SB 10-157

SUBJECT: MAIN LANDING GEAR LOCKING

EFFECTIVITY: All TB 20 and TB 21 aircraft

Figure 1 - Spring and guides - Removal / Installation

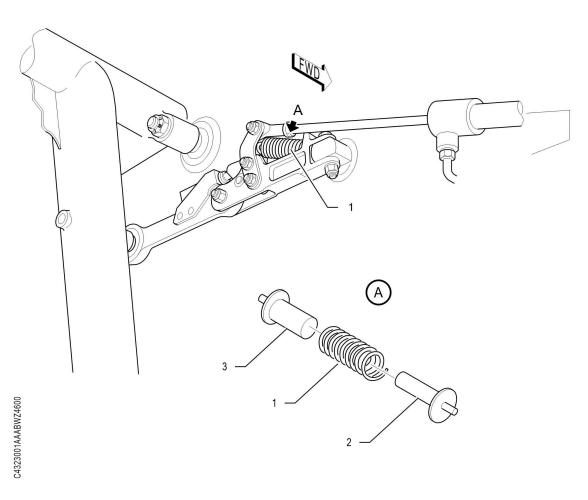
B. PROCEDURE - See Figure 1

1) Using any appropriate means, compress and remove the assembly spring pin guide (2) / spring (1) / spring socket guide (3).

2) Inspect the three removed parts.

3) Apply a thin coat of grease AIR 4210B — MIL—PRF—23827C (Type II) or equivalent on spring pin guide (2) external face and spring socket guide (3) internal face.

THE SPRING SOCKET GUIDE MUST BE INSTALLED TOWARDS THE INBOARD SIDE OF THE AIRCRAFT.

4) Reinstall spring pin guide (2), spring (1) and spring socket guide (3).

- 3) Discard spring pin guide (2), spring (1) and spring socket guide (3) previously removed.
- 4) Apply a thin coat of grease AIR 4210B MIL-PRF-23827C (Type II) or equivalent on spring pin guide (2) external face and spring socket guide (3) internal face.

THE SPRING SOCKET GUIDE MUST BE INSTALLED TOWARDS THE INBOARD SIDE OF THE AIRCRAFT.

5) Install spring pin guide (2), spring (1) and spring socket guide (3).
